West Island Line Project

Proposal for Alternative Air Monitoring Station of AM1
(Rev A)

Figure 3 Alternative Monitoring Location (AM1a)

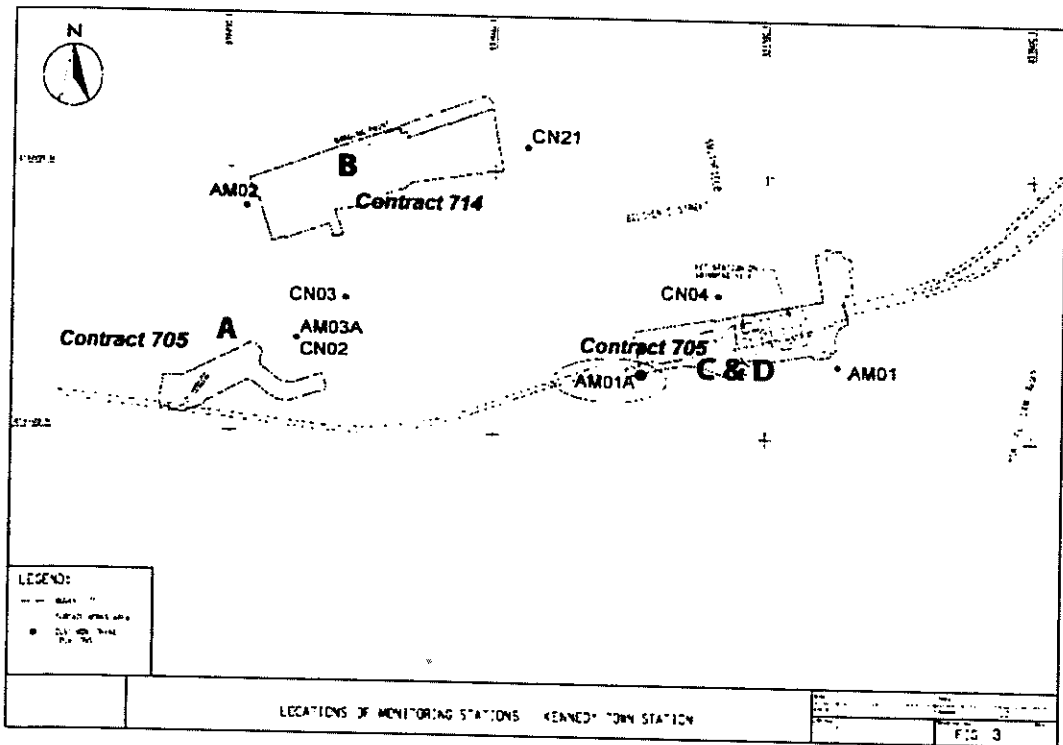
For the Air Monitoring Location at Pokfield Garden, because of the reasons as mentioned above, an alternative location is identified at ground level of Kwun Lung Lau Block 1 as shown in **Figure 3** which satisfies the criteria mentioned above. The air sampler is proposed to be installed at ground level adjacent to the captioned building.

The alternative location for AM 1 – Pokfield Garden is therefore proposed as AM1a Kwun Lung Lau Block 1.

The proposed alternative air monitoring station AM1a installed at Kwun Lung Lau Block 1 is situated at the boundary of Works Areas C and D similar to the original monitoring station AM1 at Pokfield Garden which is likely to have similar air quality impacts during the construction phase of the Kennedy Town Station due to the major site activities such as cut and cover excavation for the station box and the station construction. The Kennedy Town station works area is about 200m long located between AM1 and AM1a. As such the baseline data for AM1 is considered to be applicable to AM1a as the potential dust impacts resulting from construction activities at the two monitoring locations are the same. As construction work at Works Areas C commenced in April 2010, a further 2 weeks air baseline monitoring at the proposed alternative monitoring station AM1a is not feasible at the moment.
